U.S. Appl. No. 10/659,728 filed September 10, 2003

: METAL GATE ENGINEERING FOR

SURFACE P-CHANNEL DEVICES

AMENDMENT

# PROPOSED REPLACEMENT SHEET 2/2

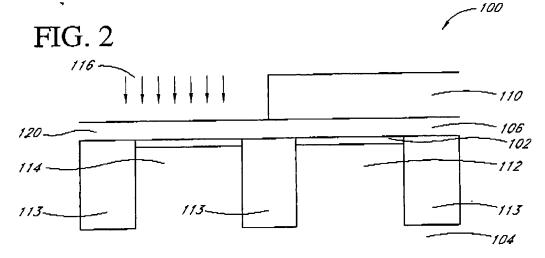
The attached "<u>Proposed</u> Replacement Sheet" includes <u>proposed</u> amendments to Figures 2 and 4. These <u>proposed</u> amendments are being made in response to the objections to the drawings by the Examiner in the Office Action. No new matter is being entered herewith.
